MASTER DEVELOPMENT PLAN No. 750-B

MASTER DEVLOPMENT PLAN
MONTERREY VILLAGE SUBDIVISION
SAN ANTONIO, TEXAS

Re: Monterrey Village MDP # 750-B

The City Staff Development Review Committee has reviewed Monterrey Village Master Development Plan M.D.P. # 750-B. Please find enclosed a signed copy for your files. Your plan was accepted, however please note the following:

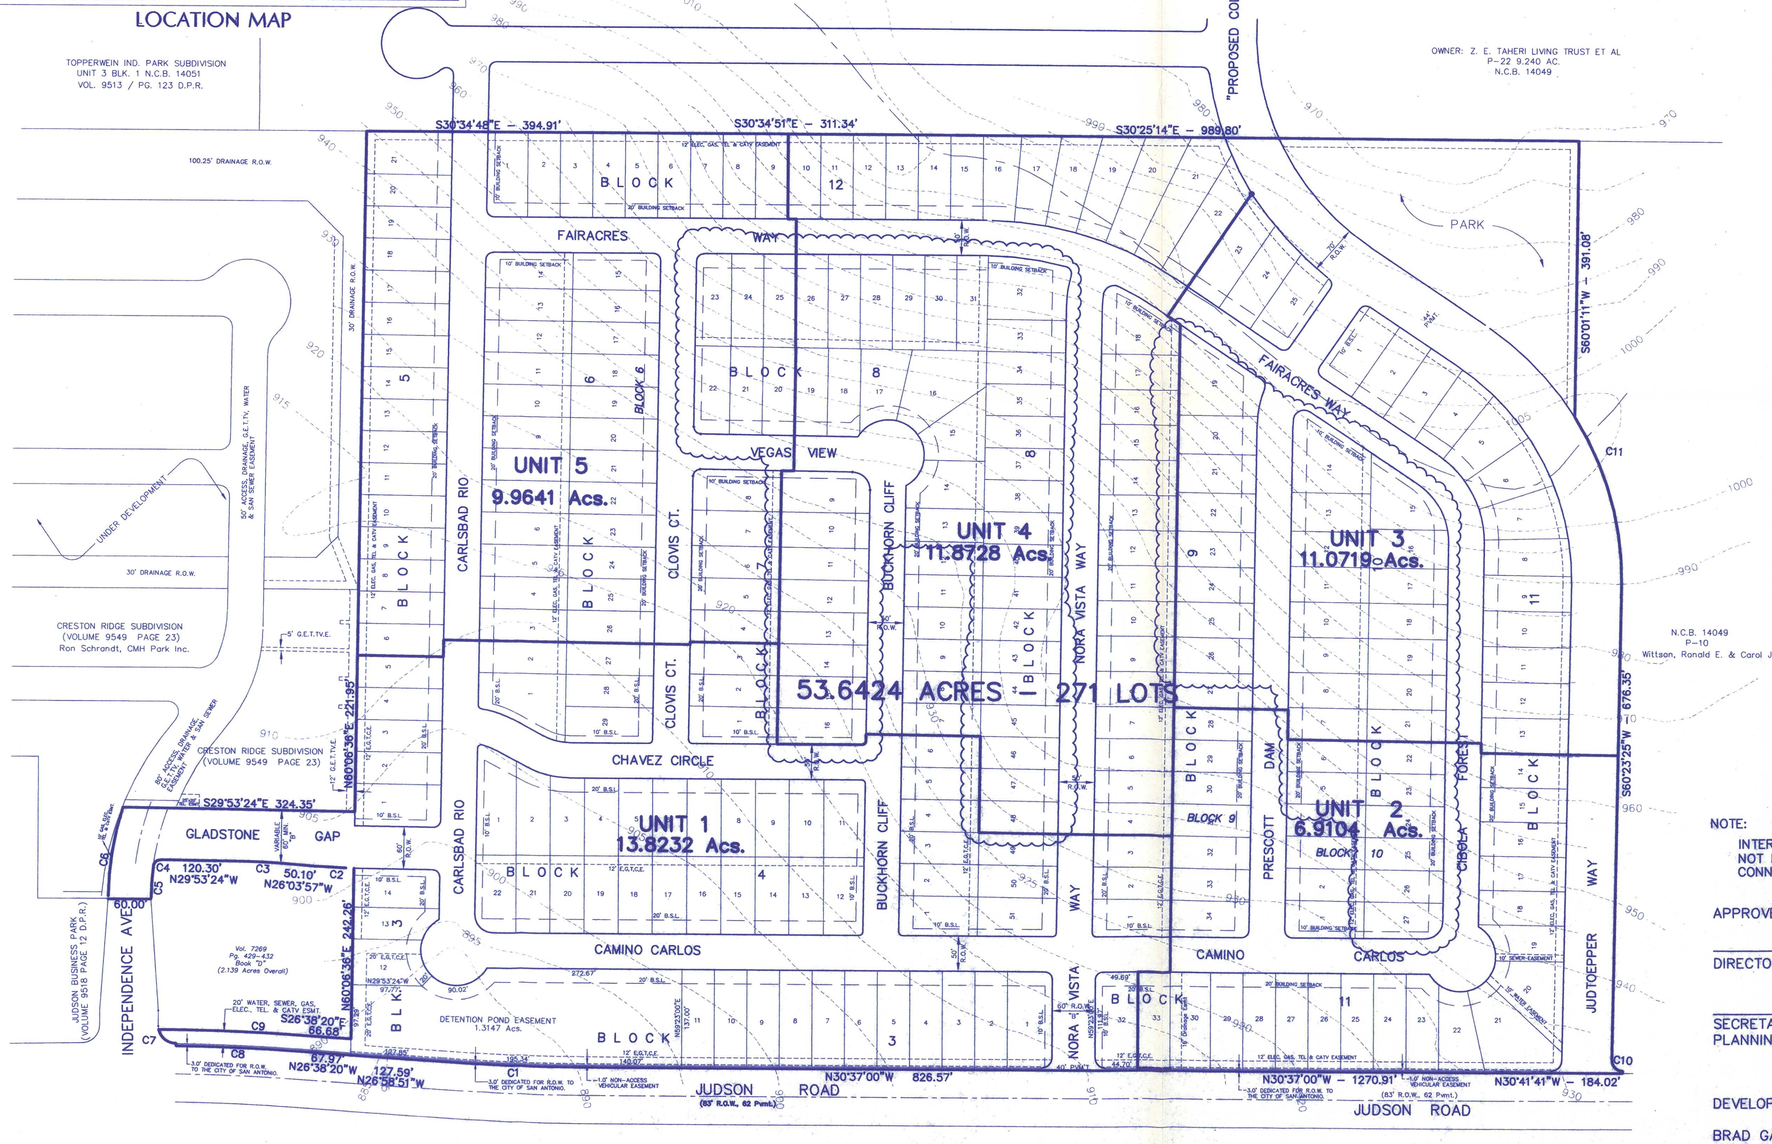
- In consideration of public safety and convenience, excessive grades by reason of topography should be avoided in street layouts and arrangements.
- Any access and R.O.W. issues along state facilities will need to be resolved with the Texas Department of Transportation (TXDOT). For information about these requirements you can contact TXDOT at 615-5814.
- This development will need to comply with tree preservation ordinance #85262. For information about these requirements you can contact Tree Preservation at 207-8053.
- It will be expected that you will plat all of the property depicted in your Master Development Plan (M.D.P.) to include floodplains, drainage areas and open space.
- I would encourage you to work closely with the school district, so that they can plan accordingly.

1. The applicant will dedicate a minimum of 1.9118 acre parcel ("Park") as identified on the Master Development Plan to the Monterrey Village Homeowner's Association, and comply with the requirements of UDC Section 35-503(f)(2). Park is to be completed with Unit 4.

2. Within the Park, the applicant must plant ten (10) trees. Each tree must have a minimum caliper of two (2) inches. Applicant may plant a minimum of two of the following species: Cedar Elm, Live Oak, Red Oak, Chinquapin Oak, or Monterrey Oak.

3. Trees shall be planted within the park parallel to the right-of-way of the collector labeled "Jud-Toepper Parkway." Trees are to be planted approximately 35 feet on center and meet the requirements listed in Section 2 above.

4. The applicant shall install four (4) picnic units in the Park. Each unit must consist of a picnic table, benches, cement slab, and garbage receptacle. Tables and benches must be concrete or metal.

5. The applicant shall install an Open Play Area. This area is to be a minimum of 20,000 square feet of unobstructed space with a maximum slope of five (5) percent. Common Bermuda or similar turf grass is to be established in this area.
